CALIFORNIA COASTAL COMMISSION

REVISED CONDITIONS AND FINDINGS

Application No.: 6-03-098/A-6-NOC-05-050

Applicant: Pardee Homes, Attn: Carlene Matchniff Agent: Lucast Consulting

SUBSTANTIAL CONFORMANCE REVIEW BRUSH MANAGEMENT & FIRE ACCESS EXHIBIT

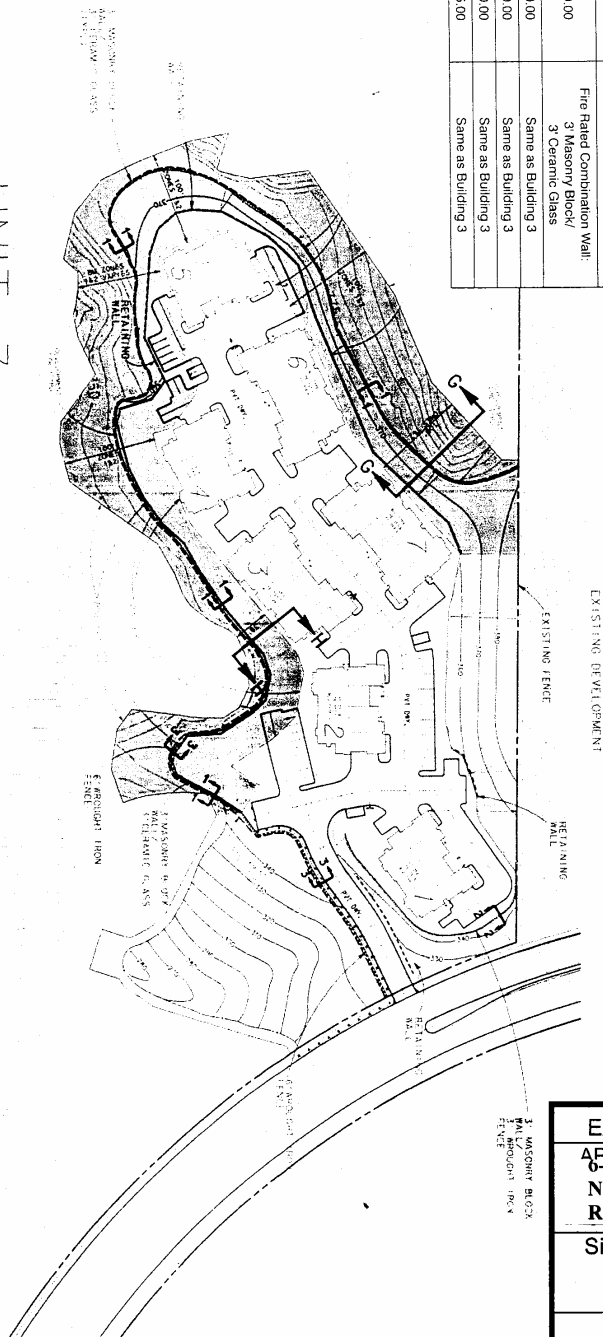
(c) Revisions to the proposed site plan, tentative map and brush management plans, as necessary, to address the full 100-foot brush management area and eliminate encroachment into coastal sage scrub, vernal pools, or wetland buffers for Zone One or Zone Two brush management may be necessary, unless the City of San Diego Fire Chief agrees to an alternative brush management plan that achieves an equivalent level of fire protection. An alternative brush management plan may use ceramic glass fire walls, provided the glass is not clear, or other materials acceptable to the City of San Diego Fire Chief and the Executive Director. An a- Alternative compliance brush management plan shall not be allowed to reduce any portion of the 100-foot Zone Two brush management area, or but may be used with the 100-foot brush management area to attain even greater fire safety and reduce the need for vegetation thinning and pruning, when the combination of structural elements, distance and allowable vegetation provides effective screening of structures consistent with Special Condition #4. If greater Zone One width, or alternative brush management features, allows for reduction in Zone Two width, the full 100-foot area should still be delineated indicating where no brush management is required. This criteria affects, but is not limited to, the proposed site plan for the following parcels: 6, 7, 8, 9, 10, 13, 17, 18, 19, 20, 21 and 22 within the Single-Family Residential area, as depicted on Substantial Conformity Review sheet 3 of 21, dated May 16, 2006; and Buildings 2, 3, 4, and 5 of the Multi-Family West parcel 127, as depicted on Substantial Conformity Review sheet 5 of 21, dated May 16, 2006.

Based on the Substantial Conformance plans dated May 16, 2006, ~~t~~The redesigned project before the Commission in this application has confined all Zone One brush management to the flat mesa tops within the designated developable area. However, not every parcel is currently designed to accommodate a full 35-foot setback from the open

space area, with less than 35 feet being provided in portions of the Multi-Family West component. This issue may be partially resolved through use of the correct certified development line for that component. The proposed plans do not show the development line as it was effectively certified by the Commission. Although the applicant has incorporated some alternative fire safety provisions in the areas where the full 35-feet may be lacking, any Zone One setback of less than 35 feet is inconsistent with the certified LUP provisions. Although alternative fire safety provisions are appropriate to further lessen the risk of future fire damage to the approved homes, they cannot replace the 35-foot Zone One setback requirement.

2. **Revised Brush Management Program.** **PRIOR TO THE ISSUANCE OF THE COASTAL DEVELOPMENT PERMIT**, the applicant shall submit to the Executive Director for review and written approval, a detailed brush management plan approved by the City of San Diego Fire Chief, for all proposed parcels adjacent to open space or within 100 feet of environmentally sensitive habitat area (ESHA), namely the Multi-Family North parcel 123, the Multi-Family West parcel 127, and the following parcels within the Single-Family Residential component: 3, 4, 5, 6, 7, 8, 9, 10, 11, 12, 13, 14, 15, 16, 17, 18, 19, 20, 21, 22, 23, 24, 25, 26, 27, 28, 29, 64, 87, 88, 111, 112, and 113 as depicted on Substantial Conformity Review sheets 3, 4, and 5 of 21, dated May 16, 2006. The brush management plans shall delineate the area within 100 feet of all proposed habitable structures on each of the identified parcels. The brush management plan shall be overlain on the vegetation mapping to document that Zone One and Zone Two brush management does not impact any coastal sage scrub, vernal pools or wetland buffers. Said plans shall be approved by the City of San Diego Fire Department and shall include the following components:

- (a) The area between 0 and 35 feet (at a minimum) from any habitable structure on each parcel shall comprise Zone One brush management, and shall consist of the following:

- (b) The area between Zone One and 100 feet from any habitable structure shall comprise Zone Two brush management, and shall consist of the following:

EXHIBIT NO. 7
APPLICATION NO. 6-06-098/A-6-
NOC-05-050
Revised Findings
Open Space Restriction Parcels
California Coastal Commission

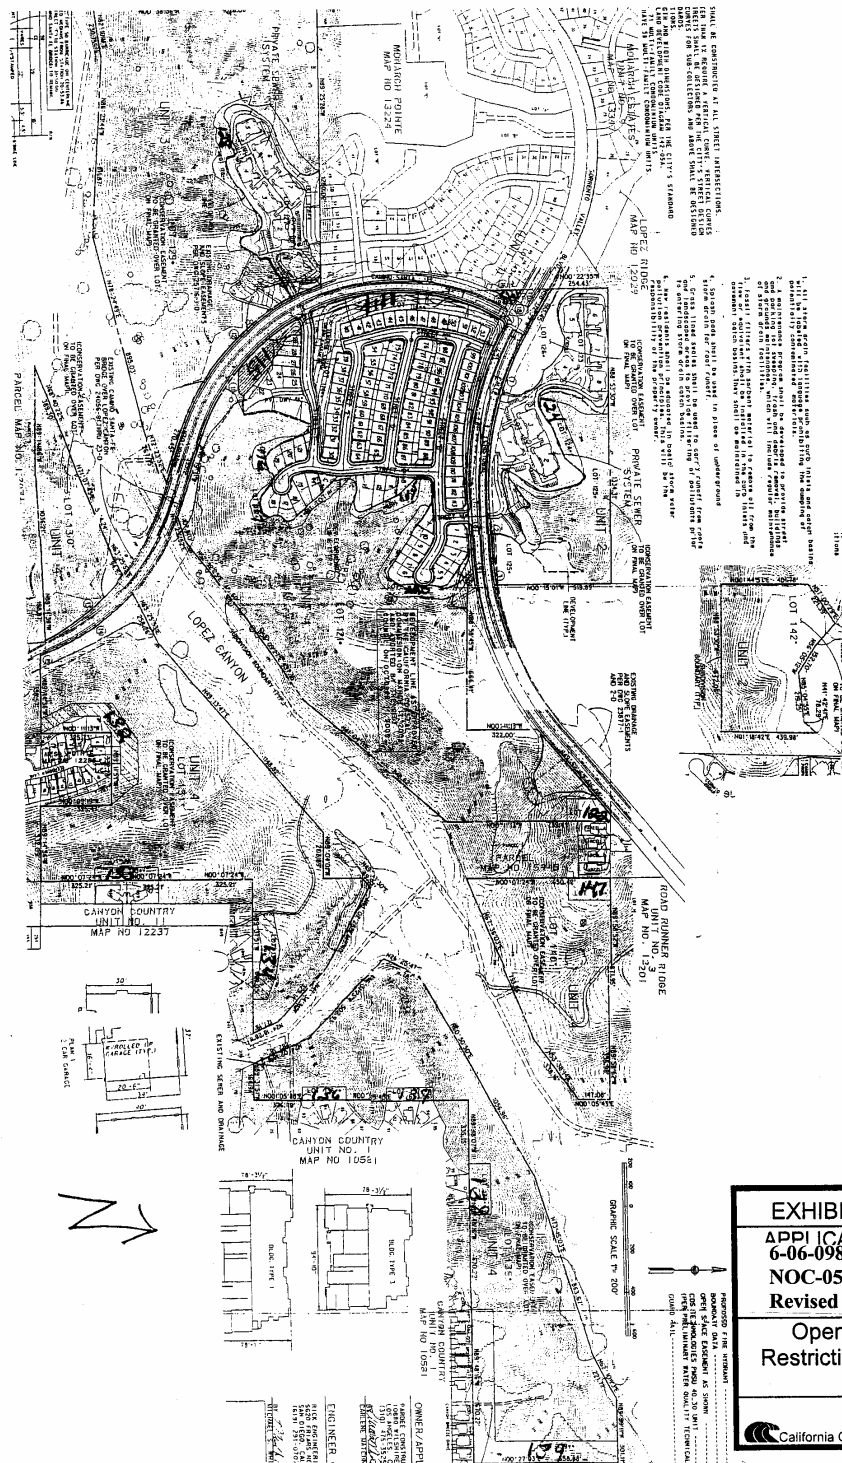
- A. No development, as defined in Section 30106 of the Coastal Act, shall occur within parcels 114, 115, 116, 117, 118, 119, 120, 122, 124, 128, 132, 133, 134, 136, 137,

138, 139, 141, 143, and public overlook/park parcels A, B, and C as depicted on the Vesting Tentative map dated May 16, 2006 and Exhibit #7 except for:

1. Zone Two brush management as specified in Special Condition #5 of this permit
2. ongoing maintenance activities within existing drainage easement on parcel 139
3. installation of meandering walkways and seating on parcels A, B, and C
